ESK-96-054

Subject: Quad Cities Nuclear Power Station, Units 1 & 2
Commonwealth Edison (ComEd) Response to NRC Request for Additional
Information on April 4, 1996, Regarding Unit 2 Corner Room Steel Operability
Evaluation

NRC Docket Nos. 50-254, and 50-265

Attachment No. 1 Stability Load Calculation Sketch

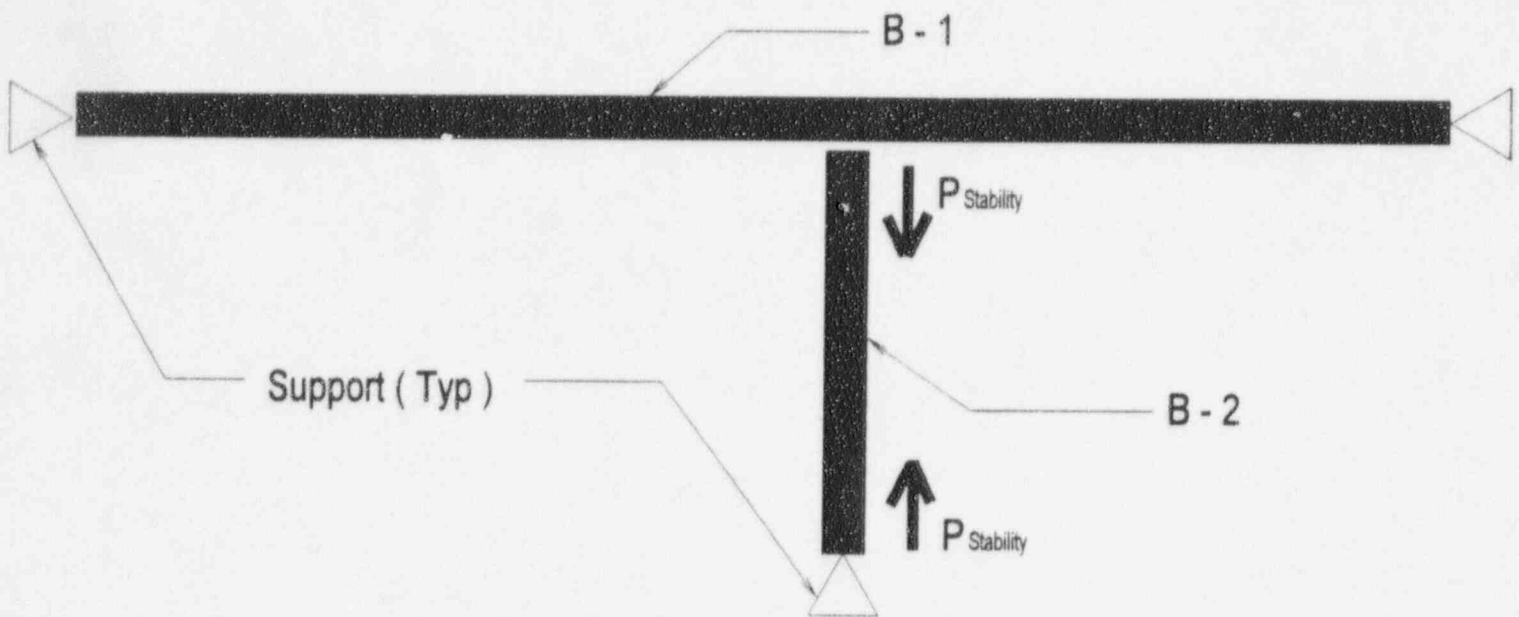
Question 1) Provide a clarification to the previous response to Item 4b in Reference 2. In your response include an explanation of stability loads and why they are applied.

Question 3) Provide an example of a beam which had a high interaction coefficient that was caused by torsion, which could be reduced by relieving the rigid torsional moment. Include in this example, an evaluation that demonstrates how the torsional moment applied by the support is relieved.

In the design of a primary beam which is laterally supported by other, secondary beams, pseudo stability loads are added to verify that the laterally supporting beams and their connections are stiff enough to laterally support the primary beams. A pseudo stability load is a preliminary design force used in the evaluation of secondary members that provide lateral support to primary compression and/or flexural members. This load is characterized as "secondary effect" because it is not a result of an external force or moment applied to the framing as in the case of a pipe hanger, floor live load, seismic inertial loads, etc.. Its sole purpose is to ensure that the stiffness of the brace is adequate to prevent excessive buckling or twisting of the primary framing member being laterally supported. A second order analysis (P- Δ effects) of the entire structural framing is another method of achieving the same result.

In an effort to simplify the design and still be confident of the stiffness of the bracing members, pseudo stability loads were used. The magnitude of the stability load is a function of the compressive force in the flange of the member being braced and is only applied to the brace and its connections. Since it is not an externally applied force to the framing system, it is not considered in the overall frame analysis. In the attached sketch (Attachment 1), bracing member B2 is designed for the force required to laterally support beam B1.

Pseudo stability loads need not be combined with environmental loads (i.e. thermal, gravity, seismic) because they are, in effect, redundant relative to stiffness. If the size of a brace (that has been designed for stability loads) increases as a result of environmental loads, then the minimum requirements for stiffness are still satisfied without penalizing the design. The minimum stiffness of bracing members are verified by the use of this stability assessment, but these loads are not required to be included in load combinations.

The preliminary interaction coefficients for the right end connection of beam 2 were 8.64 for angle bending and 8.50 for web bending under Operating Basis Earthquake (OBE) load combinations and 5.56 and 5.29 respectively for the SSE load combinations. With consideration of the reduction in torsion from the pipe support auxiliary steel the SSE IC's become 0.43 for angle bending and 0.51 for web bending. Since both IC's are less than the acceptance criteria, this revised calculation demonstrates that the functional stress limits are maintained.
